**LOUISIANA 1 IMPROVEMENTS
GOLDEN MEADOW TO PORT FOURCHON**

**REVISED RECORD OF DECISION
FEBRUARY 2011**

**U.S. DEPARTMENT OF TRANSPORTATION
FEDERAL HIGHWAY ADMINISTRATION
RECORD OF DECISION (Revised February 2011)**

(SUMMARY: The Record of Decision (ROD) signed January 2003, revised May 2004, and March 2009, is being revised again to include updated minor refinements (planned, designed or under consideration) in the project.)

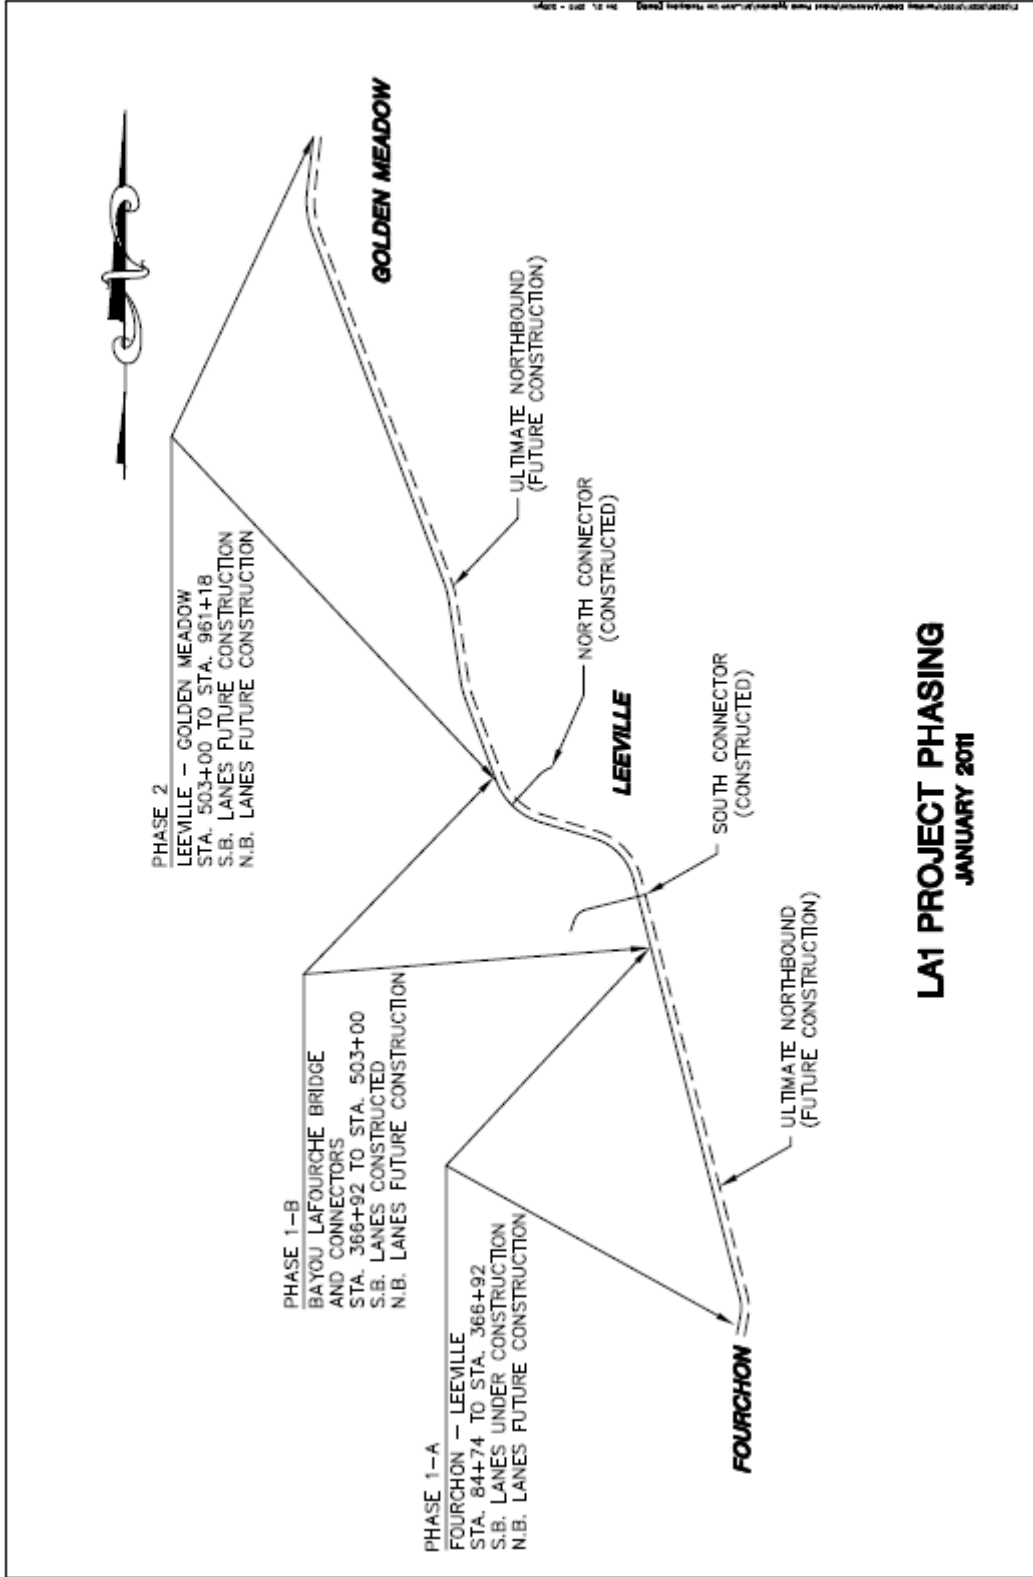
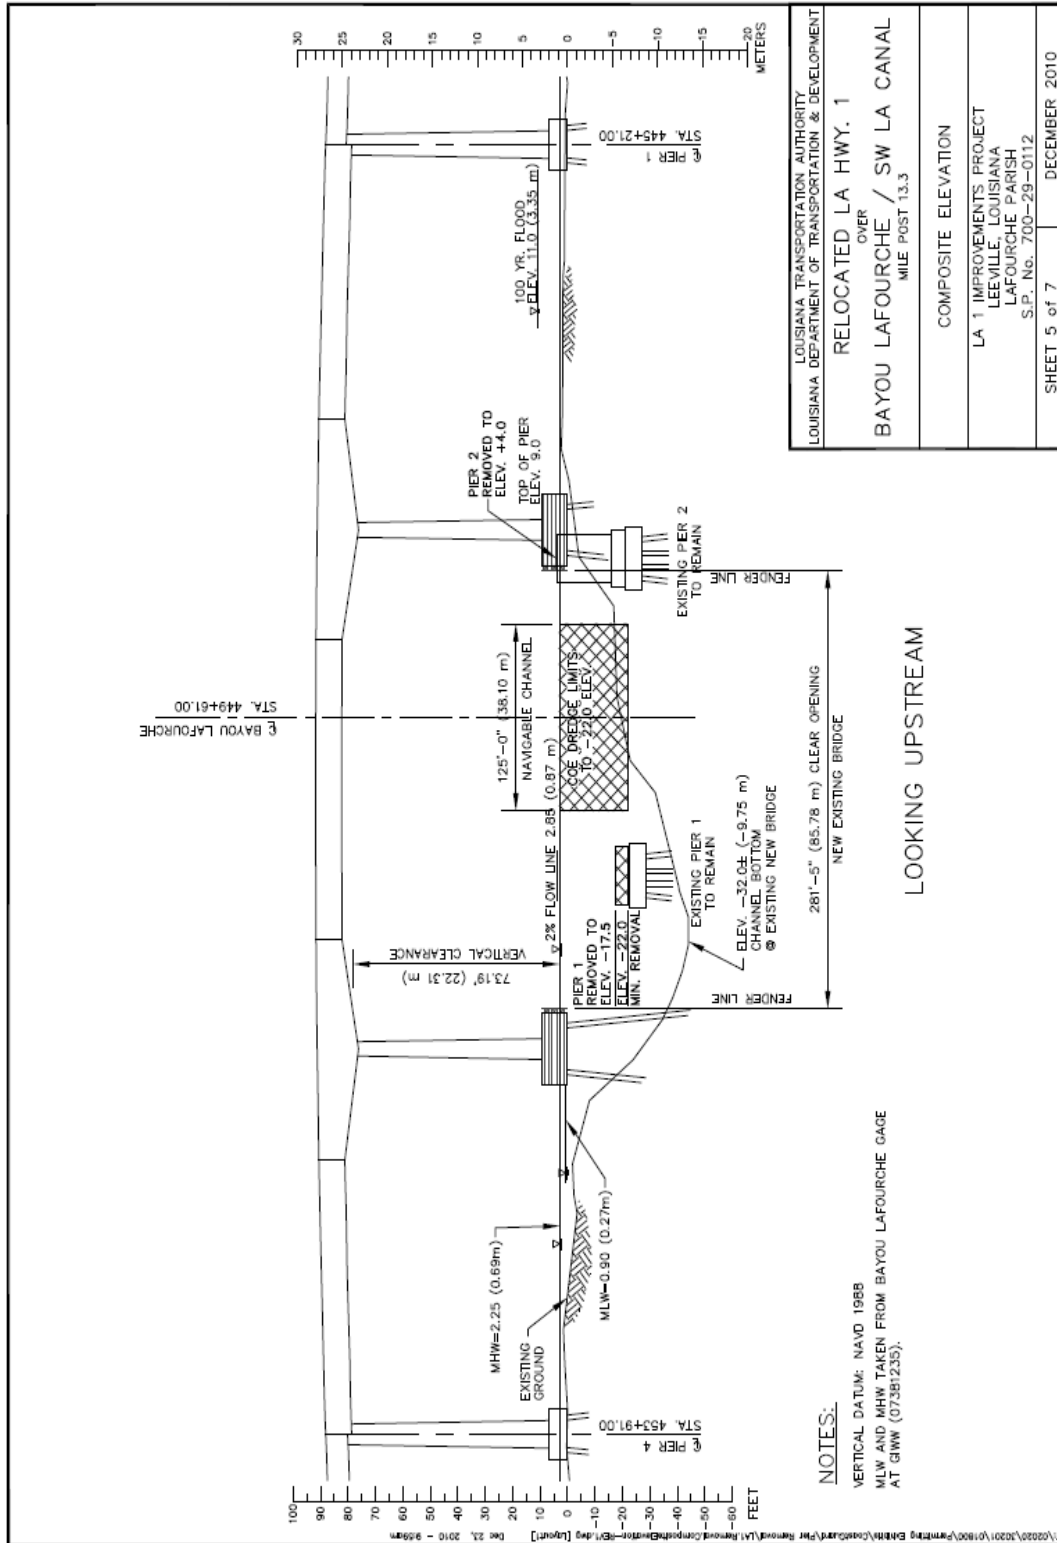
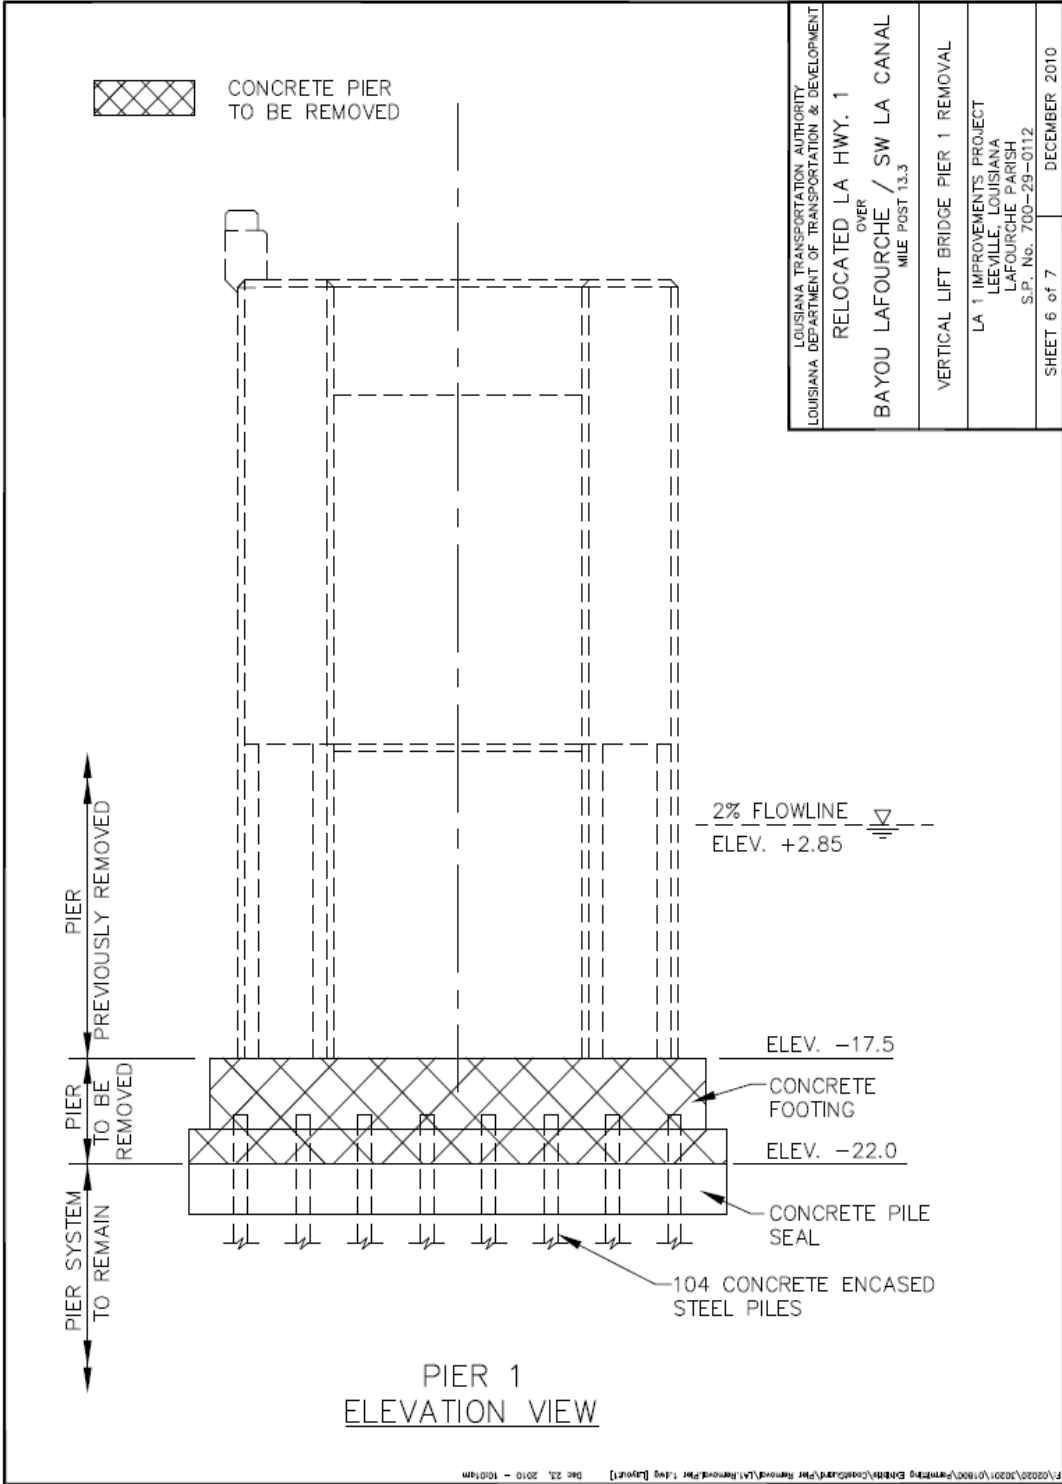
The original permit called for the removal of the old bridge piers to "mud line." The permit information utilized the as built drawings which show the mud line at -16 National Geodetic Vertical Datum (NGVD) for the pier located in the waterway (Pier 1). The channel, Bayou Lafourche, is maintained by the Corps at a depth of -12 NGVD for navigation. When the old bridge was dismantled, the pier was removed to -17.5 NGVD which is below both the mud line shown on the as built plans and the navigational requirement. An issue arose during bridge removal when it was discovered that the actual mud line at the pier in the waterway was much lower due to severe scouring at the pier. Measurements were taken on April 26, and July 6, 2010, that indicated that the scour moved the mud line to -32 NGVD and sediment is not accumulating at the pier location.

On November 4, 2010, DOTD and FHWA met to discuss the project status, the pier removal, and the need to provide the 55 ft. clearance at Bollinger Canal. At this meeting, several alternatives to remove the remaining portion of the pier were mentioned as possibilities. It was decided that the DOTD would investigate several options and coordinate with NMFS via telephone conference. The general consensus was that -22 NGVD was the appropriate depth for removal rather than actual mud line now located at -32 NGVD.

On November 16, 2010, staff from the project team informed the U.S. Coast Guard of DOTD's intention to submit a request for a permit modification to allow the removal of pier 1, the pier in the waterway, to -22 NGVD rather than -32 NGVD, the actual mud line, and to allow pier 2, the pier at the bank, to remain at the elevation of +4 NGVD. The U.S. Coast Guard followed up with a request for additional information to issue the public notice. DOTD will address comments received as a result of the public notice in accordance with permitting requirements.

PIER 2
ELEVATION VIEW

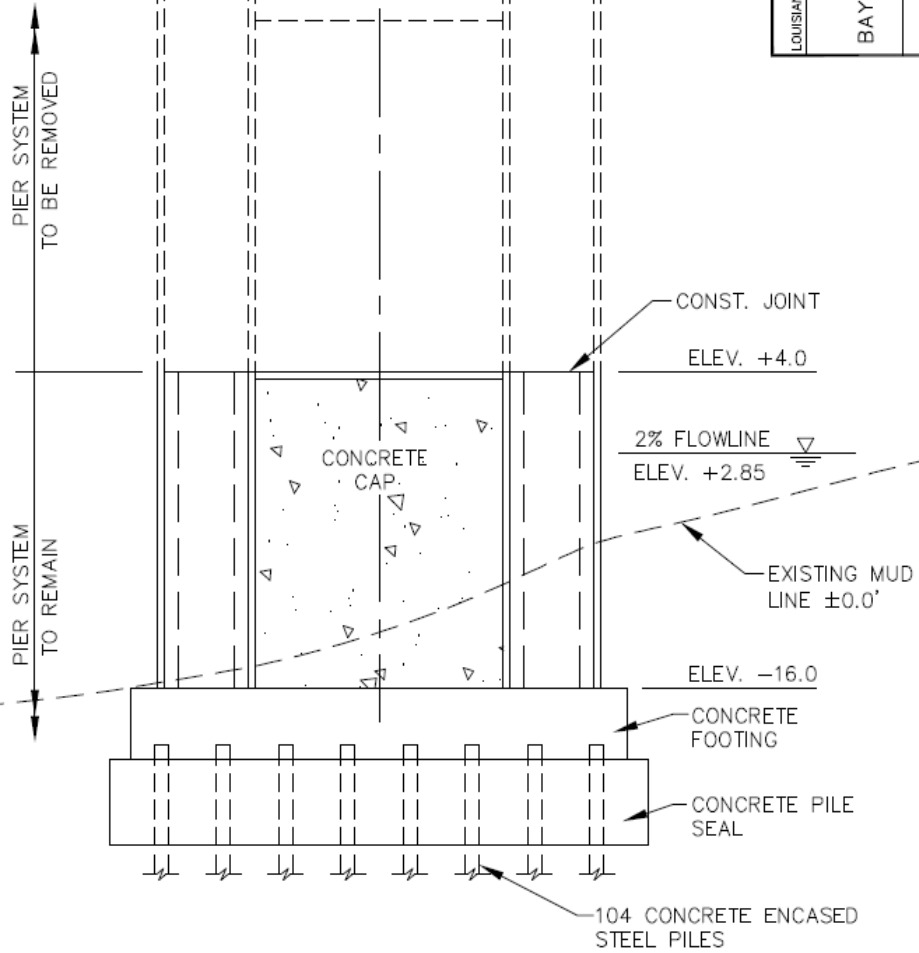
Also, the pier located at the east bank (Pier 2) was not removed to mud line. Upon coordination with permitting agencies, this pier was left in place at +4 NGVD due to its location. The concern is that if the pier were removed to mud line and the bank thereafter eroded, the pier remnants would be exposed underwater. The consensus was to leave the pier plainly visible along the bank.

Comments were received from the Joint Public Notice of the applications for the Coastal Use and Corps permits for bridge removal. The Greater Lafourche Port Commission (GLPC) on August 27, 2009, and the U.S. Coast Guard Port of Morgan City on September 2, 2009, objected to leaving the pier in Bayou Lafourche at an elevation of -16. Follow-up meetings were held with concerned parties, and it was decided that the pier in the waterway be removed to at least -22. (It may be removed to a lower depth depending on technique used for removal, pier design, further consultation with agencies, etc.) See figures in appendix. Additionally, during permit modification process, should the agencies require the pier located at the bank be removed, DOTD will comply; otherwise, it will remain at +4, plainly visible.
